Re: Lee County Solid Waste Energy Recovery Facility  
Groundwater and Surface Water Monitoring Plan  
Response to Comments PPSC PA 90-30

**LEE COUNTY SOLID WASTE ENERGY RECOVERY FACILITY  
RESPONSE TO FDER COMMENTS**

Power Plant Siting Act Permit Application PA 90-30  
Lee County, Florida

This report provides responses to comments raised by the Florida Department of Environmental Regulation regarding the Surface Water and Groundwater Monitoring Plan for the Lee County Solid Waste Energy Recovery Facility.

LEE COUNTY SOLID WASTE ENERGY RECOVERY FACILITY  
 MONITORING WELL LOCATIONS AND  
 GROUND WATER CONTOUR LINES

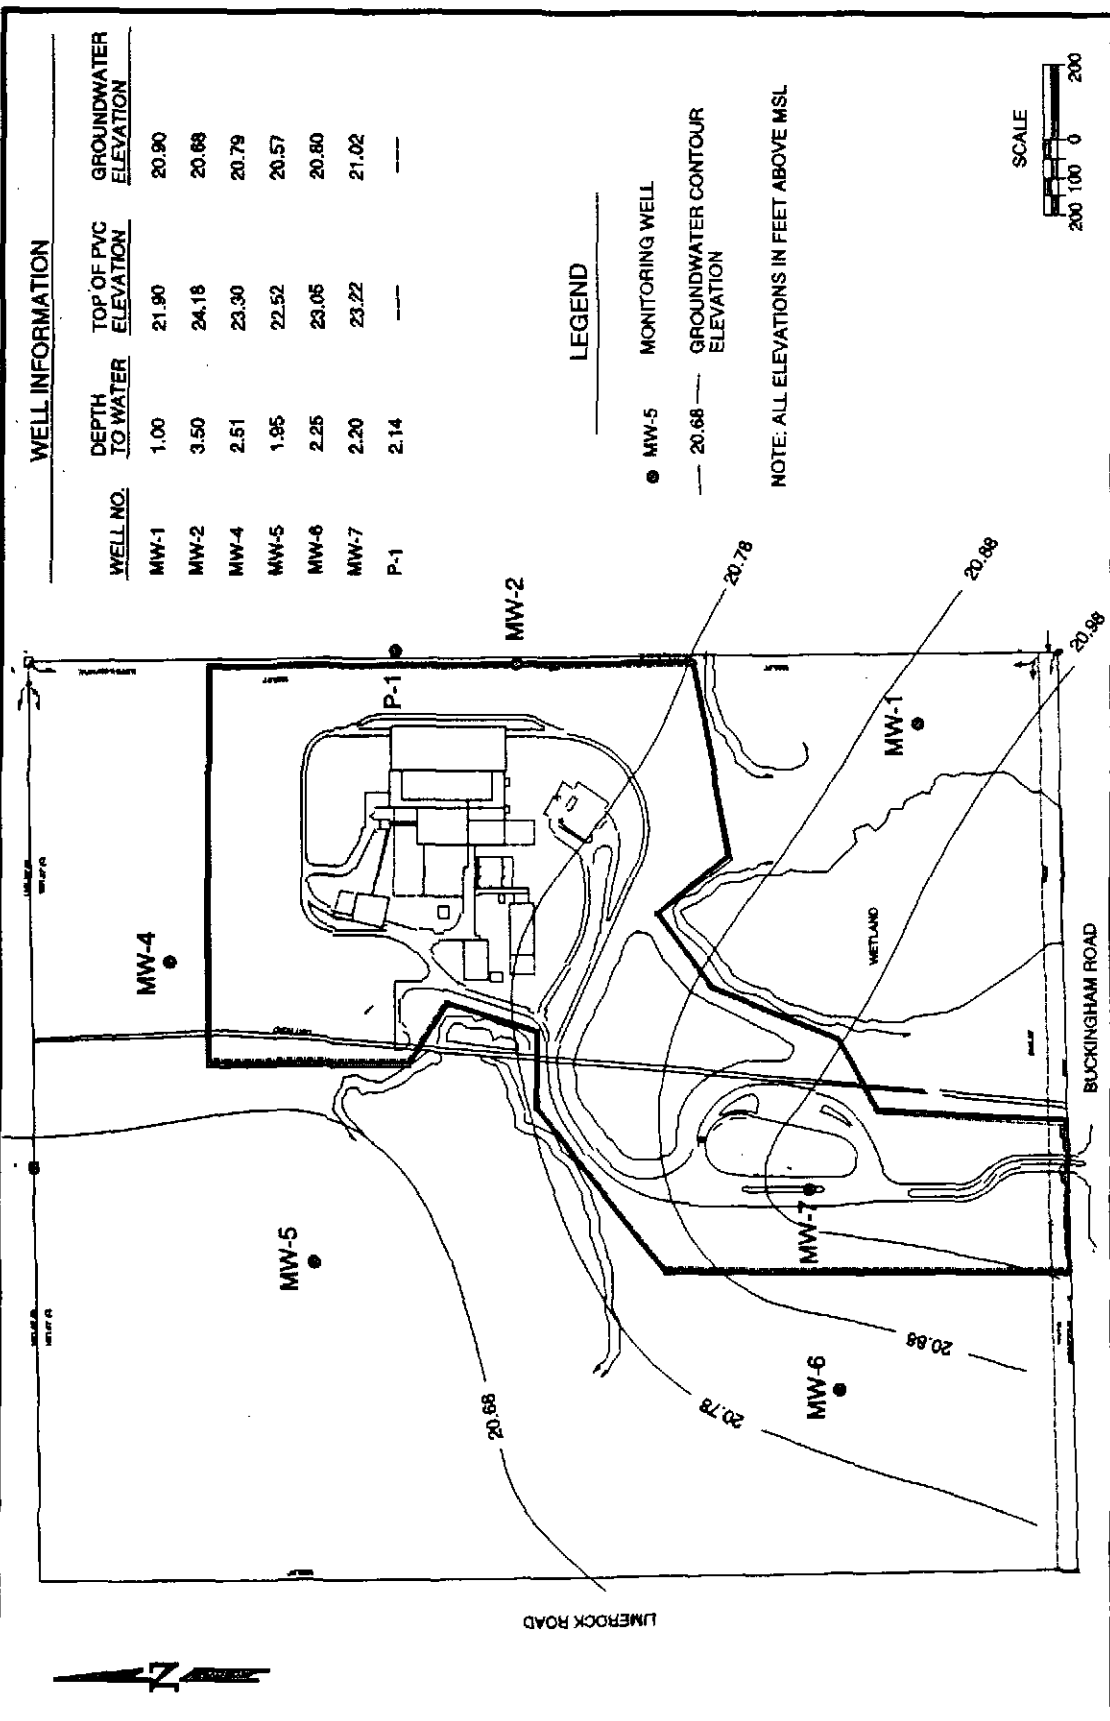
**The site-specific ground water flow direction derived from measurements made by Mortensen Engineering was determined to be southeasterly. The method and accuracy of the measurements do not appear adequate to reflect true site conditions in consideration of the regional data which suggests a northerly flow direction. Please provide site-specific ground water elevation information, obtained through reliable means, which defines the direction of flow at this location.**

- 1) The site-specific ground water flow direction derived from measurements made by Mortensen Engineering was determined to be southeasterly. The method and accuracy of the measurements do not appear adequate to reflect true site conditions in consideration of the regional data which suggests a northerly flow direction. Please provide site-specific ground water elevation information, obtained through reliable means, which defines the direction of flow at this location.

Six monitoring wells have recently been installed at the Lee County SWERF site. These wells are screened in the surficial aquifer and were installed to monitor groundwater quality during the dewatering operations. Static water levels were measured in the six monitoring wells on September 28, 1992. The locations and top of casing elevations of the wells were surveyed so that groundwater elevations could be determined. The well locations and groundwater elevations were plotted on a survey map and groundwater contour lines were established. The locations of the wells and the groundwater contour lines are shown on Figure 1.

As shown on Figure 1, groundwater movement in the surficial aquifer is generally to the northeast. This is consistent with the regional groundwater flow direction. The horizontal hydraulic gradient across the site is relatively flat and is calculated to be 0.0003 feet/foot.

REVISED FIGURE 11

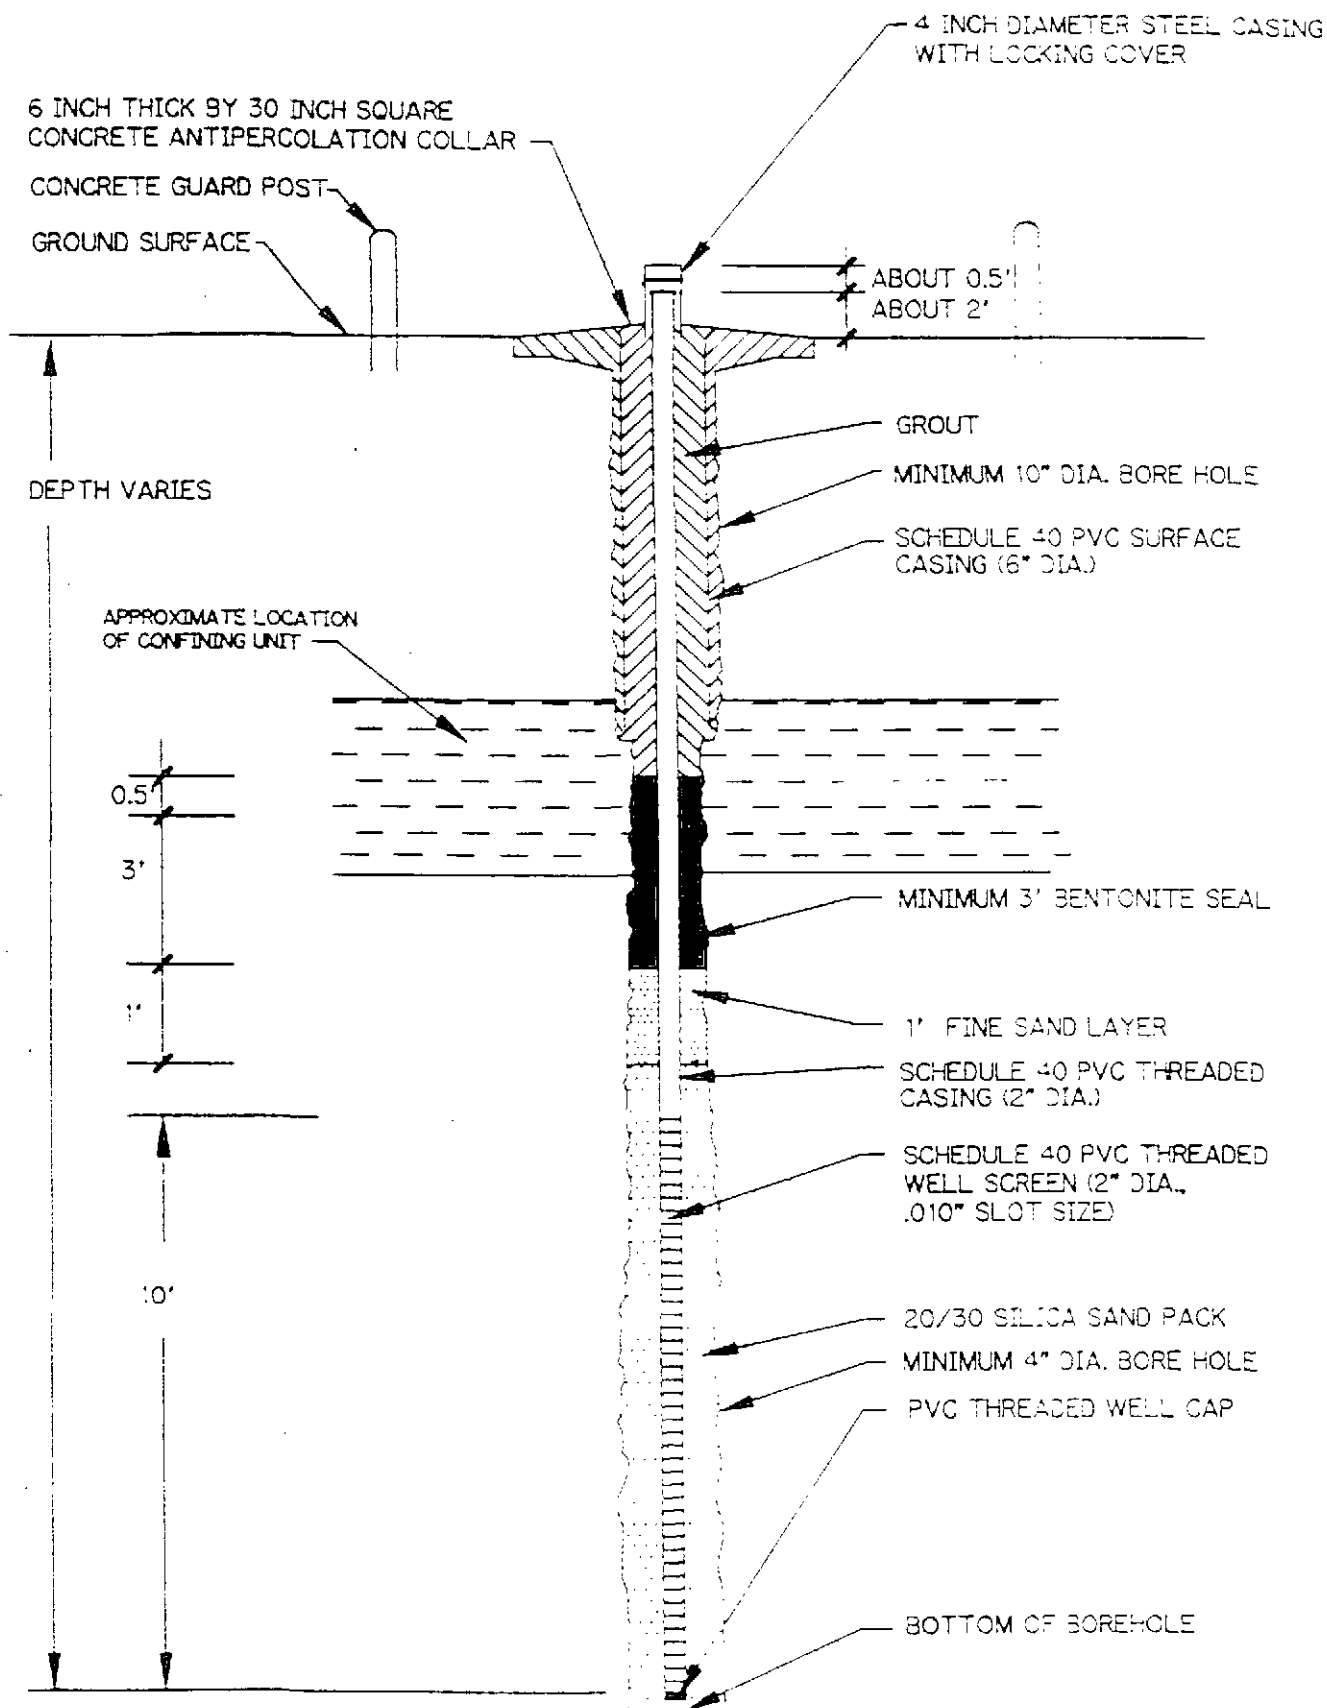
**The typical construction detail drawings of monitor wells are not consistent with the text. Of particular concern is the fine sand layer shown above the bentonite seal which would be located within the confining layer for intermediate depth wells. Please review the construction details and revise, as necessary, to resolve any inconsistencies.**

- 4) The typical construction detail drawings of monitor wells are not consistent with the text. Of particular concern is the fine sand layer shown above the bentonite seal which would be located within the confining layer for intermediate depth wells. Please review the construction details and revise as necessary to resolve any inconsistencies.

The well construction for the intermediate depth wells will not include a 0.5 foot thick fine sand layer above the three foot bentonite seal. The typical construction detail for the intermediate monitor wells (Figure 11 of the Monitoring Plan) has been revised to be consistent with the text of the Monitoring Plan and is attached as Revised Figure 11. The reference to the 0.5 foot fine sand layer has been removed.
